SUNDRY NOTICES AND REPORTS ON WELLS
Do not use this form for proposals to drill or to re-enter an abandoned well. Use Form 3160-3 (APL) for such proposals.

8. Well Name and No. **Farrell Federal # 12**

Proposed Plug & Abandonment Procedure

Farrell Federal 12
30-041-10460
Ridgeway Arizona Oil Corp
September 5, 2019
Conditions of Approval

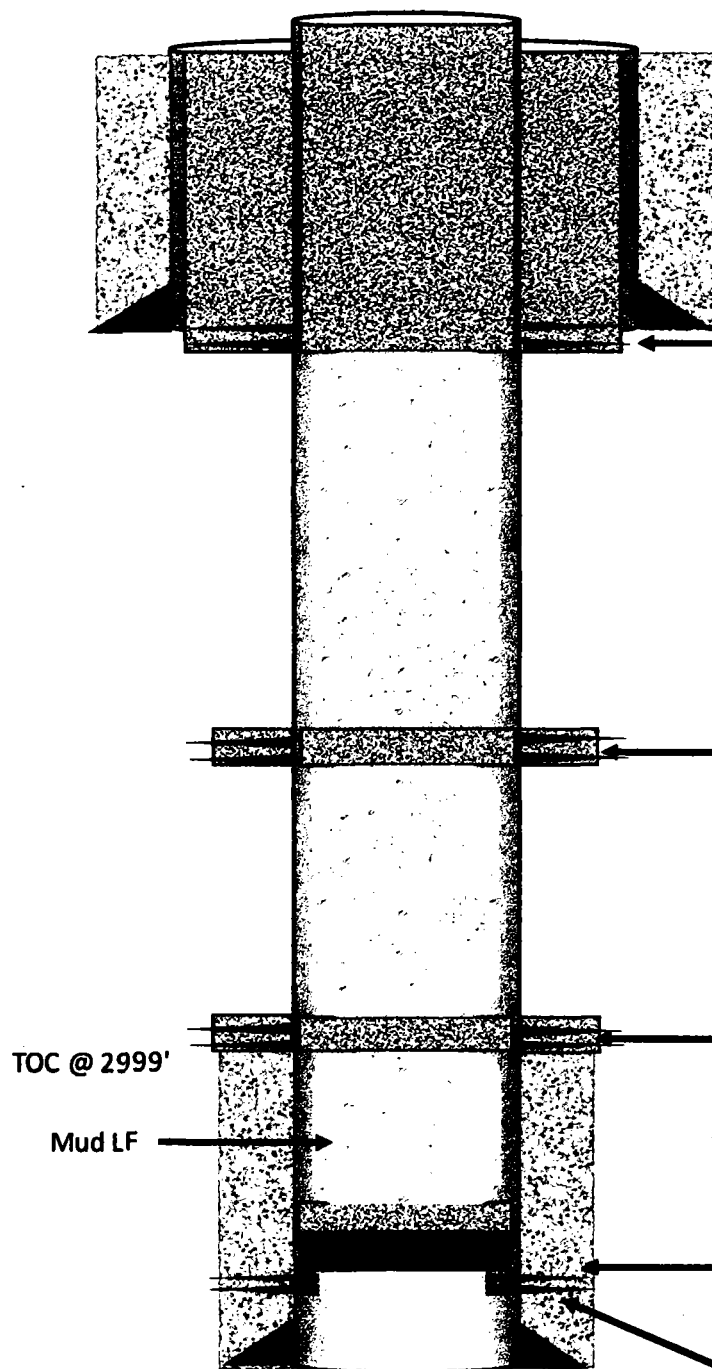
1. Operator shall place CIBP at 4,182' (50'-100' above top most perf) and place 25 sx of Class C cement on top as proposed. WOC and TAG.
2. Operator shall perf and squeeze at 3,049' as proposed. Operator shall place a balanced Class C cement plug from 3,049'-2,949' as proposed. WOC and TAG.
3. Operator shall perf and squeeze at 2,330'. Operator shall place a balanced Class C cement plug from 2,330'-2,205' to seal the Yates Formation and the bottom of the Salt. WOC and TAG.
4. Operator shall perf and squeeze 50 sx of class C cement as proposed at 1,950'. Operator shall place a balanced Class C cement plug from 1,950'-1,800' to seal the top of the Salt. WOC and TAG as proposed.
5. Operator shall perf and squeeze at 462' as proposed. Operator shall place a balanced Class C cement plug from 462' to surface to seal the 8-5/8" casing shoe.
6. See Attached for general plugging stipulations.
